Zoning Plan Examination Checksheet Response

BES PLAN EXAMINATION CHECK SHEET

Job Name: Alta Mira Residence

Re: Structural Plan Review

FB3 a.wwb

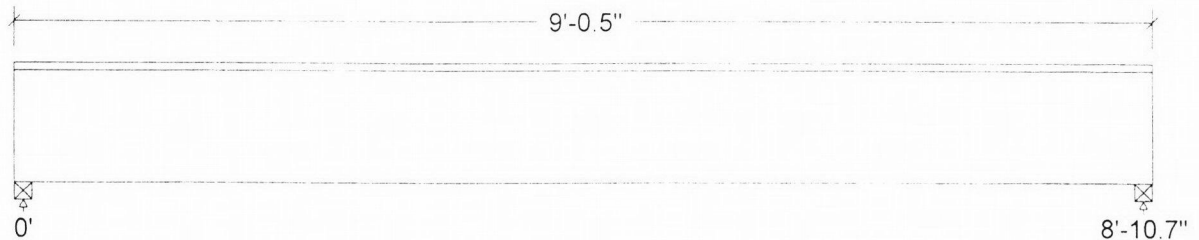
C6 shows the calculation for support of FB3 only. FB3 occurs at 2 locations and now spans 8'-9". See attached revised calculation for FB3 specifying a 5-1/8"x10-1/2" GL beam. The total reaction for FB3 is 5773 lbs. C6 posts down on retaining wall footings with a minimum width of 2'-3". No additional spread footings are needed at these columns. C6 can be a (2)-2x6 DF #2 post – see attached calculation.

Glulam-Unbal., West Species, 24F-1.8E WS, 5-1/8"x10-1/2"
